## Groundsmaster<sup>®</sup> 3000 series units

## Subject: Support bearing may allow Cooling Fan to move towards radiator

## FAN HUB INSTALLATION INSTRUCTIONS for Groundsmaster 3000 series units

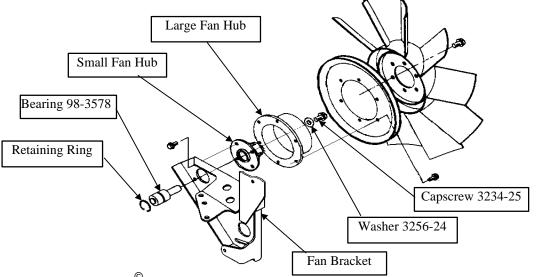
Some of the units listed above may have an insufficient press fit between the bearing and hub that support the engine cooling fan. This may allow the fan to move towards the radiator and create belt misalignment. The design of this assembly now includes a capscrew to assist the press fit in retaining the parts in position. The conversion parts and installation instructions for the improved design are listed below.

## Parts Needed=one 98-3578 Bearing, one 3234-25 Capscrew, and one 3256-24 Washer

- 1. Remove Retaining Ring and press original Bearing out of large Fan Hub.
- 2. Press Bearing out of small Fan Hub and discard Bearing.
- 3. Install replacement Bearing (98-3578) and Retaining Ring into small Fan Hub.
- 4. Install the Bearing and small Fan Hub into the large Fan Hub until the shaft is flush.
- 5. Install Capscrew (3234-25) and Flat Washer (3256-24). Torgue to 20 ft-lbs (2.8 Kgm).
- 6. Install Fan Hub Assembly and tighten mounting fasteners to 20 ft-lbs (2.8 Kgm).
- 7. Install all remaining parts removed during disassembly.
- 8. Adjust the Radiator Shroud to ensure there is adequate fan clearance on all sides.
